CITY OF CLEVELAND HEIGHTS
**FINAL ACTIONS OF THE
PLANNING COMMISSION**
ON WEDNESDAY, NOVEMBER 12, 2025

Project No. 25-22 Severance Town Center Proposed Zoning Text Amendment (Ord. No. 226-2025) and Zoning Map Change (Ord. No. 227-2025), referral from City Council regarding the zoning map to create a Zoning Overlay District for the entire Severance Circle properties (inside and outside of the ring road) zoned 'S-1' Mixed-Use and adjacent properties (PPNs 683-33-003 and 683-33-004 per Code Chapters 1111, 1115, 1121, 1131, 1145, 1151, 1153, 1161, 1165, & 1166.

Planning Commission Comments on Ordinance No. 226-2025, Exhibits A & B

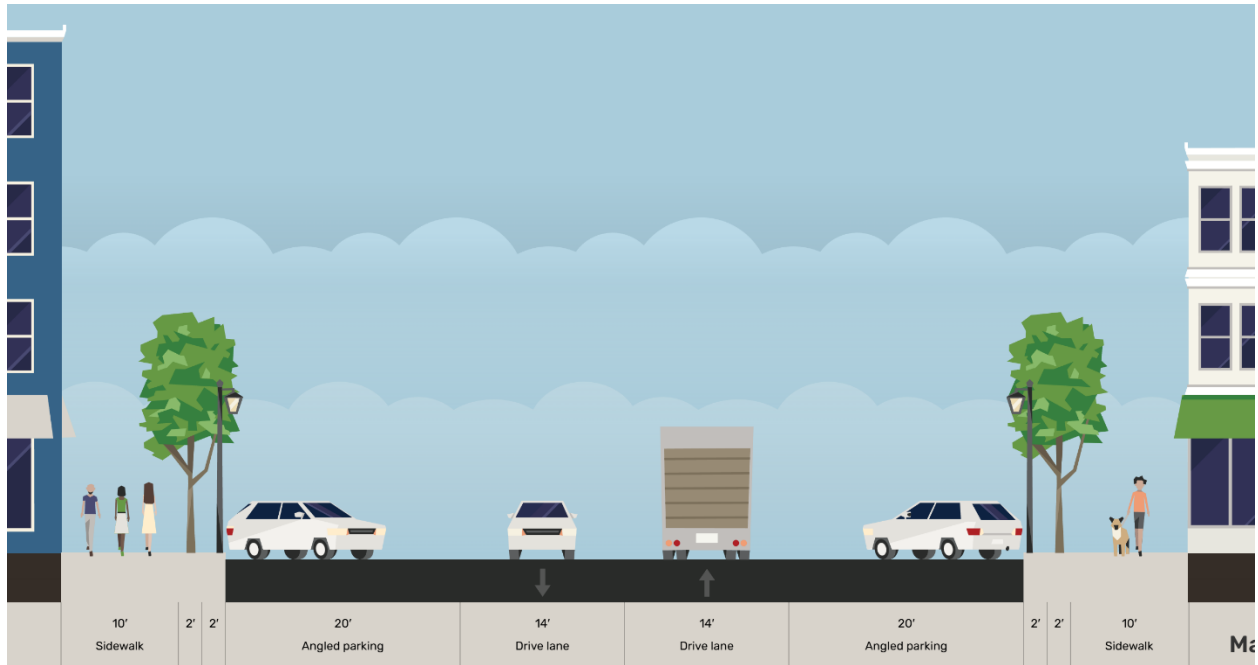
Page 1 Chapter 1149.03 C	Proposed insertion: add at the end of that sentence, “...and the application is approved pursuant to Chapter 1149.”
Page 3 Chapter 1149.11 B	Format so it is clear that the District Standards Legend is 1149B(1) and the additional statements above the District Standards Map are 1149B(2), 1149B(3), and 1149B(4)
Page 3 Chapter 1149.11 B District Standards Map	- Format to make the District Standards Map more readable by having the Map and the Legend symbols and colors match: - The colors for the “Severance Overlay Zone Boundary” and “Retail or Office Required” - The size of the dashes for “Pedestrian Path Required” - The color and symbology for “Protected Area”

The shades of purple for SO-1 and SO-2 are very close and could become an accessibility issue if printed in black and white; change the colors
Page 4 Chapter 1149.11 C (2) Street Types Map	Change the roadway types for the Staunton Road Extension and connector to Crest Road to a P Street (Pedestrian Path); rename roadways accordingly
Page 7 Chapter 1149.12 B	In the Public and Private Frontage Standards table, Street Types Add a statement making it clear that the “Street Type A” standards applies to all “A” streets, “A1, A2, A3 and A4”; and that the Street Type C standards applies to all “C” streets “C1,C2,C3 and C4”; and that Street Type D standards applies to all “D” streets “D1,D2,D3 and D4” and that the Street Type “P” standards apply to all “P” streets “P1, P2, and P3”.
Page 11 Chapter 1149.21 A Table of Permitted Uses	- Under Office change Research and Development from a P (Permitted Use) to CU (Conditionally Permitted Use) in the SO-1/SO-2 districts - Under Residential add Single-family/detached and Two Family in SO-3 as CU (Conditionally Permitted) (MPACT to develop standards before next Planning Commission Meeting) - Under Residential add Community Room as A (Accessory Use) in SO-1/SO-2 and SO-3 - Under Arts & Culture change Museum and Art Gallery from a P (Permitted Use) to CU (Conditionally permitted) - Under Institutional change Religious/Charity from X (Not Allowed) to CU (Conditionally Permitted) in the SO-3 District; change it from CU to P in the SO-1 and SO-2 Districts to be consistent with other Institutional Uses - Under Light Industrial remove Data Information Center (not to be allowed in any of the districts)

Severance B-1 Design Comparison

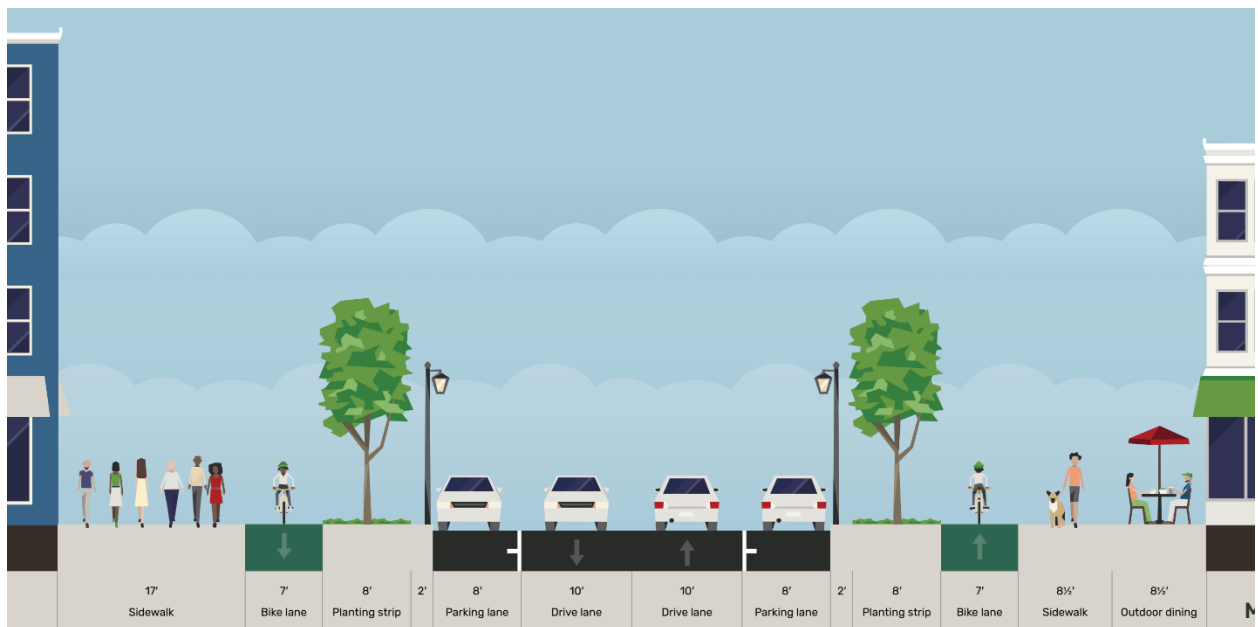
Page 29 Chapter 1149.43 A Street A-1	• There should be a dimension on the bike lane (BL) in the graphic. The standards call out a dimension for "PB." The graphic and the dimensions should be consistent.
Pages 37-49 1149.43A -1149.43M Street	• Recommend Drive Lane (DL) have maximum width of 10 feet. (diagram is last 2 pages of Attachment A)
Page 51 Chapter 1149.45 B Pedestrian Clearway Design Standards	• Remove Note (3) stating "Pavement materials shall be approved by the Architectural Board of Review"
Page 66 Chapter 1149.48 I Edging Element Design Standards	• Correct numbering: Landscape Edge should be EE-5
Global within Chapter 1149	• Capitalize Zoning Administrator
